Proposed Revisions to a Standard Plans Index

Originator:	Turley, Joshua	Index Number:	649-010
Date:	2/6/2024	Sheet Number(s):	2 and 3
E-mail:	Joshua.Turley@dot.state.fl.us	Index Title:	Steel Strain Pole

STEEL STRAIN POLE

INDEX
649-010

SECTION A-A

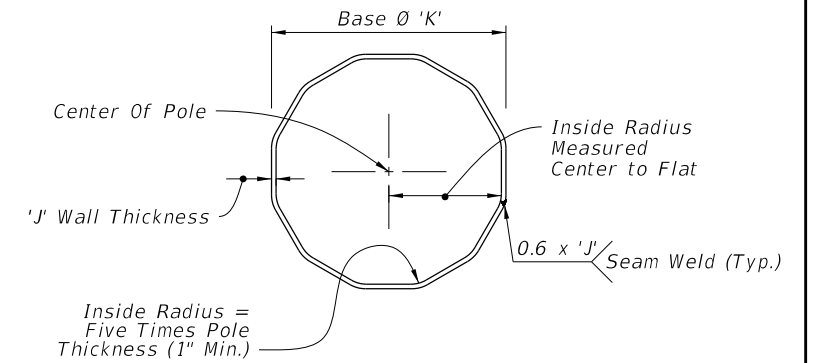
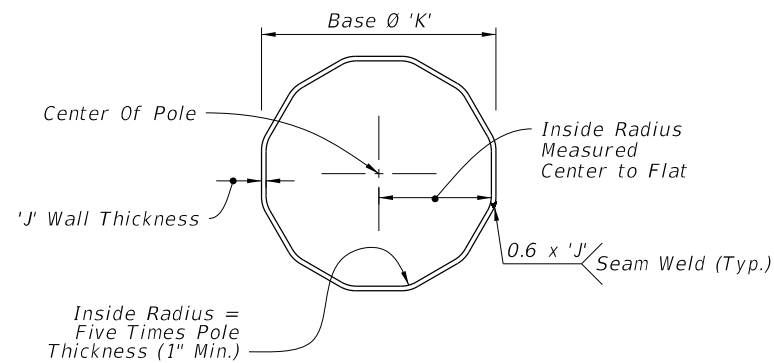
Sheet 2: Section A-A - Revised the label order of the anchor bolt nuts. DETAIL "A" - removed welding hatches, Modified wall thickness from text to symbol. Removed "Pole Wall Thickness + 7/16" dimension from Joint Weld Detail. Added welding callout to Joint Weld Detail.

HANDHOLE

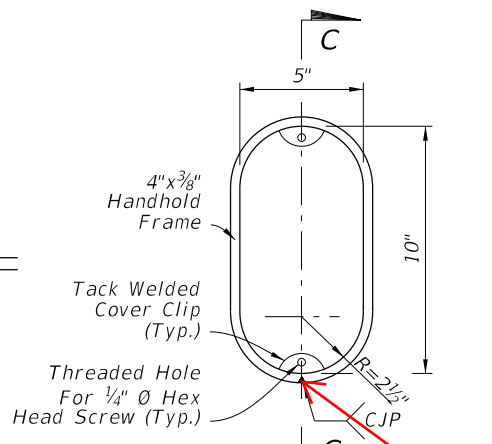
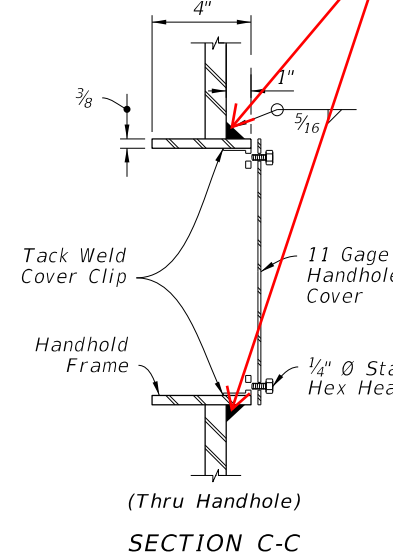
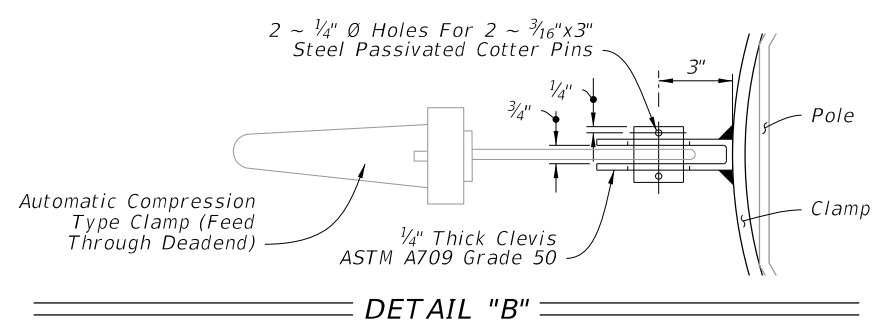
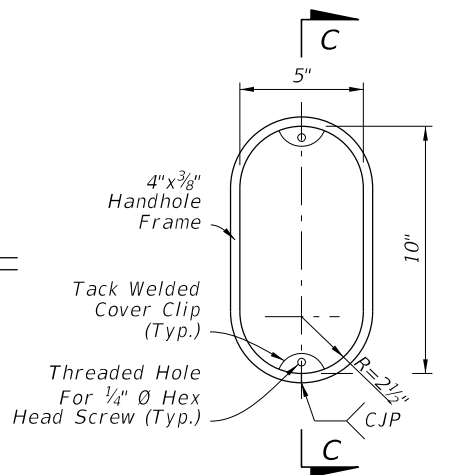
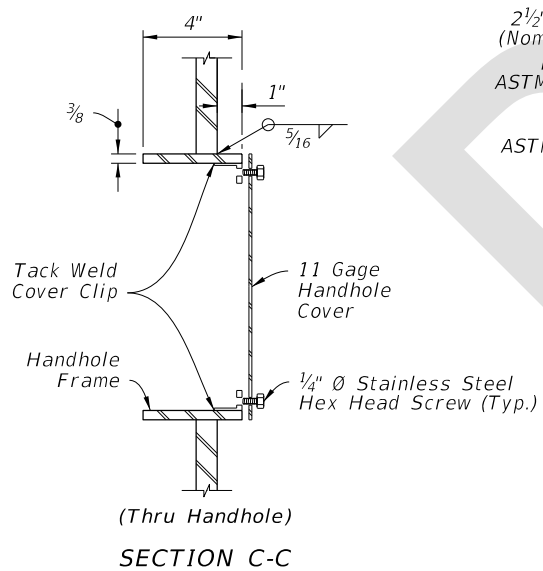
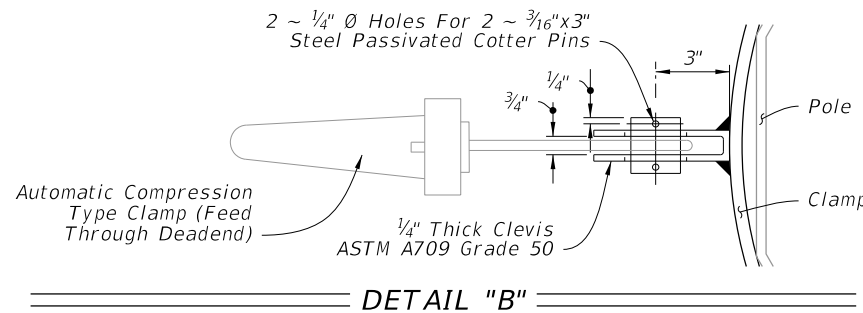
Sheet 3: Removed welding hatches on HANDHOLE details. Added "Handhole" to frame detail label.
